Service Bulletin UCB Upgrade to be Compatible with @Zone	
Prepared by: Nina Chen	Effective Date: August 25,2021	Model(s) Affected: Below	Bulletin Number: NB-2109010

UPGRADE GUIDE FOR THE NEW UCB

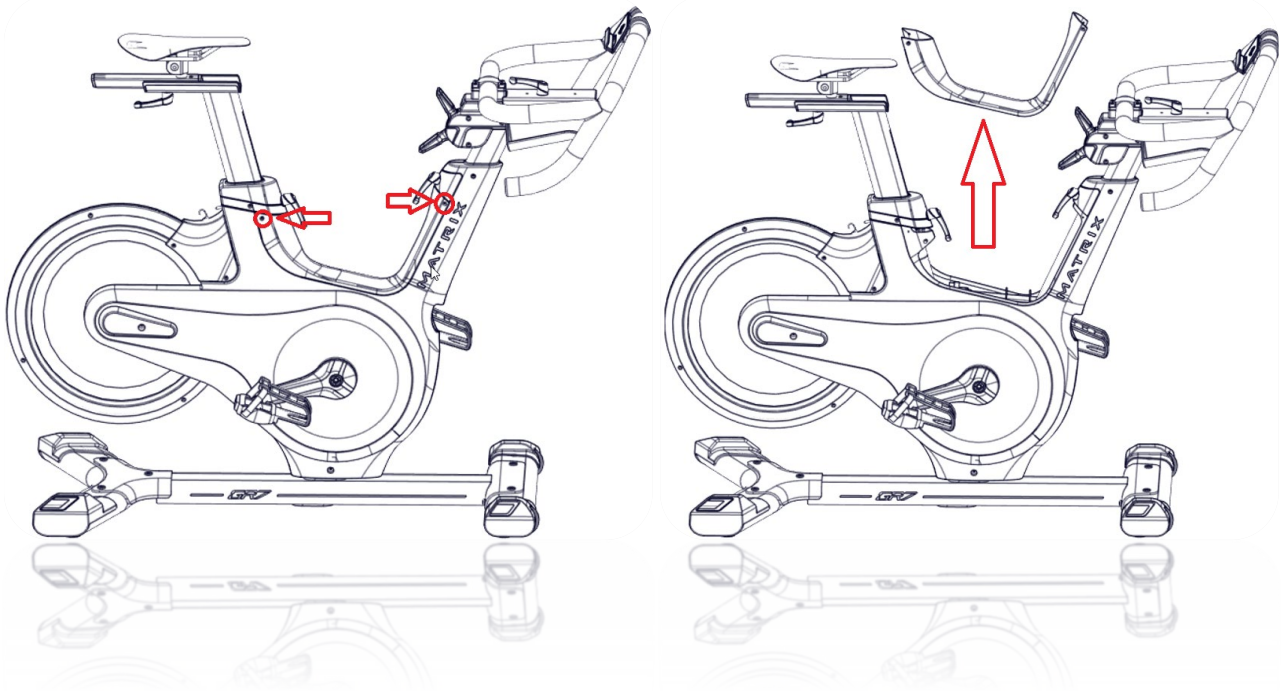
Add @zone function instrument software upgrade information statistics table.

Item	Model name	Control board material number (old)	Control board material number (new)	Software version (before upgrade)	Software version (after upgrade)	ECO number	Compatibility starting with serial number
1	Paragon X (TM733)	10004496 23(UCB)	10004660 18(UCB)	S6.24	S1.06	ECO21040 150	TM7332110C00 136
2	EliteT7.1 (TM717)	10003779 73(UCB)	10004694 40(UCB)	V9.002	V1.004	ECO21080 105	TM717D2110C0 0001
3	7.4AT-03 (TM499)	10004533 02(UCB)	10004658 29(UCB)	V1.005	V2.005	ECO21040 113	TM499D210900 653
4	Omega Z	10004496 16(UCB)	10004660 29(UCB)	S8.02	S1.06	ECO21040 151	TM7372108C00 371
5	GR7	10004464 80(LCB)	10004464 80(LCB)	Q17_V10. 15.4	Q24_V10. 24.17	ECO21060 140	FC2032106C000 801-830 FC2032106C000 861-1060 FC212B2110C0 8641

1. To upgrade the UCB for @Zone compatibility the machines listed above require a complete UCB change.
2. The previous generation of UCB boards is unable to be updated with the new software, do not update old boards with new software.
3. The GR7 requires an LCB (Lower Control Board) update.

GR7 LCB Upgrade SOP

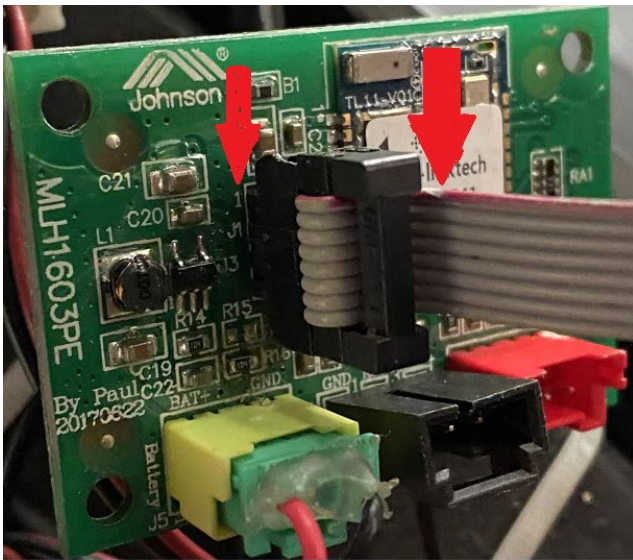
1. Use a Phillips head screwdriver to remove the screws securing the plastic panel above the flywheel and LCB compartment.

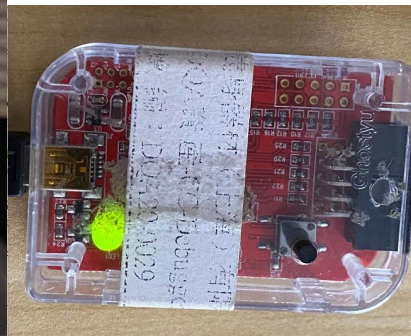
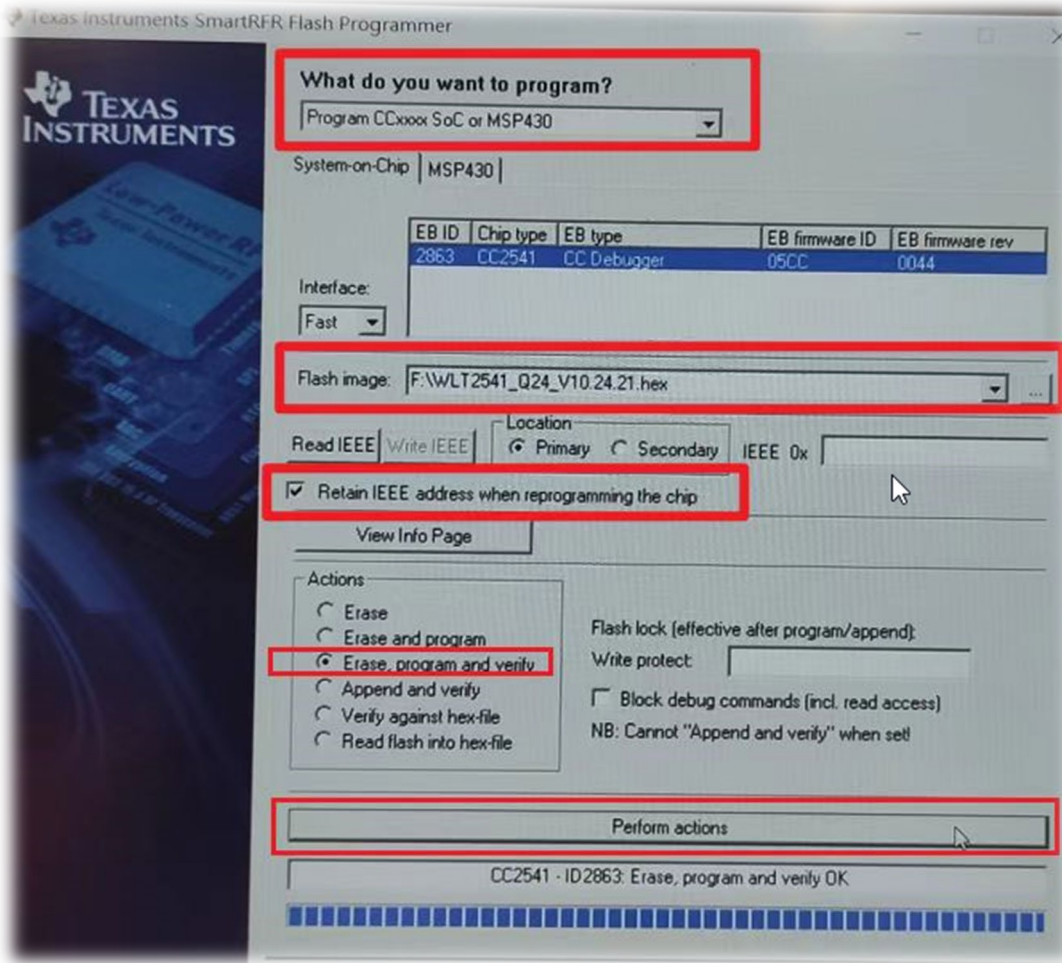
2. Connect the CC Debug device to the computer and GR7 LCB.

Make sure that the red line corresponds with the 1 pin on the LCB.
